## DEVELOPMENT APPLICATION ASSESSMENT REPORT

<b>Application Number:</b>	DA2025/0686
----------------------------	-------------

<b>Responsible Officer:</b>	Nick Keeler
<b>Land to be developed (Address):</b>	Lot 1 DP 1298188, 49 Blackbutts Road FRENCHS FOREST NSW 2086
<b>Proposed Development:</b>	Construction of a dwelling house on unregistered Lot 8
<b>Zoning:</b>	Warringah LEP2011 - Land zoned R2 Low Density Residential
<b>Development Permissible:</b>	Yes
<b>Existing Use Rights:</b>	No
<b>Consent Authority:</b>	Northern Beaches Council
<b>Land and Environment Court Action:</b>	No
<b>Applicant:</b>	Sekisui House Services (NSW) Pty Limited

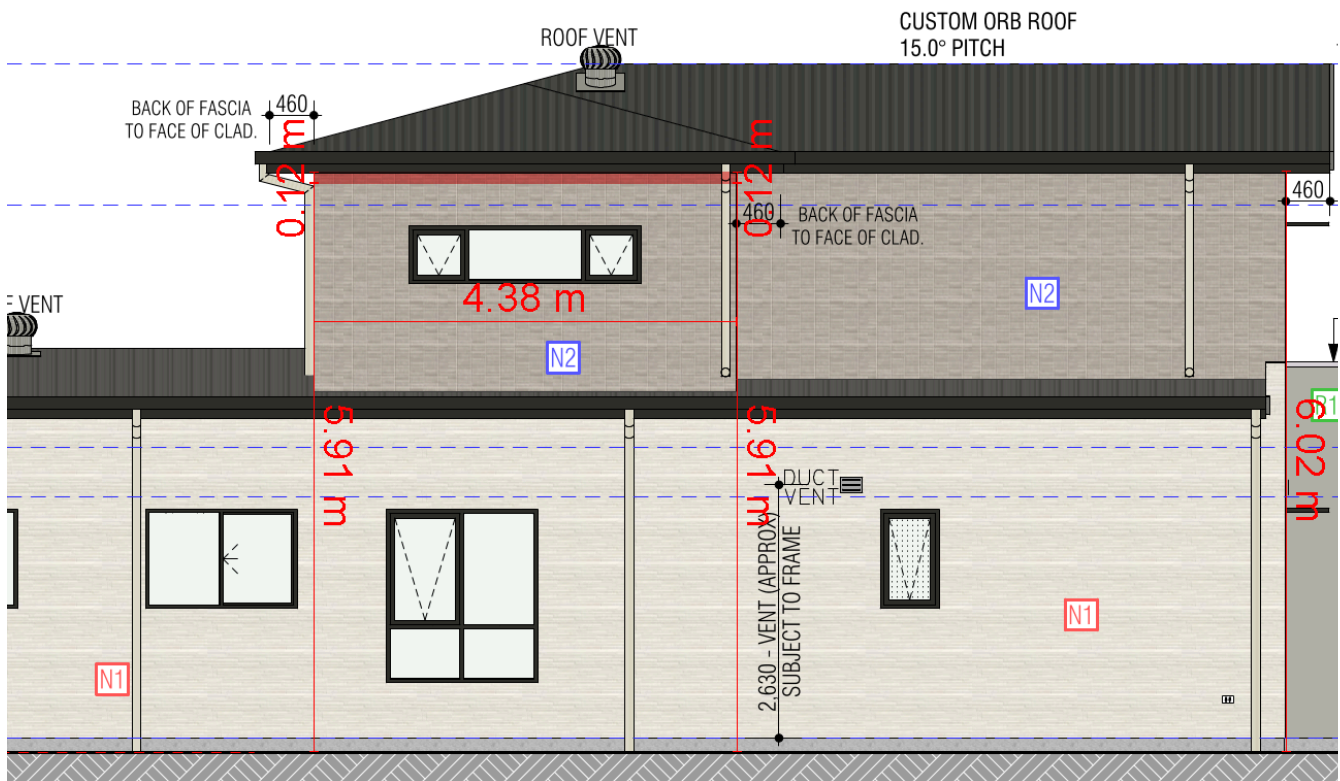
The control requires that a building must be sited within the building envelope which is determined by projecting planes at 45° from a height of 4.0m above the ground level at the side boundary.

As shown in the image below, the dwelling encroaches into the side boundary envelope along the northern elevation to a height up to 0.12m, representing a variation of 2%.

The proposed non-compliance with the building envelope control is not found to cause any unreasonable visual impacts. The dwelling is appropriately setback from the side boundaries and is sufficiently articulated to satisfy the objective. The overall built form is generally consistent with that of surrounding development.

The application has demonstrated that the proposal will not have an unreasonable impact with regards to solar access. The adjoining properties will maintained solar access in accordance with the DCP requirements.

The proposed development does not require alteration to the existing topography of the site. No unreasonable streetscape or amenity impacts are expected to arise as a consequence of the development.

Having regard to the above assessment, it is concluded that the proposed development is consistent with the relevant objectives of WDCP and the objectives specified in s1.3 of the Environmental Planning and Assessment Act, 1979. Accordingly, this assessment finds that the proposal is supported, in this particular circumstance.
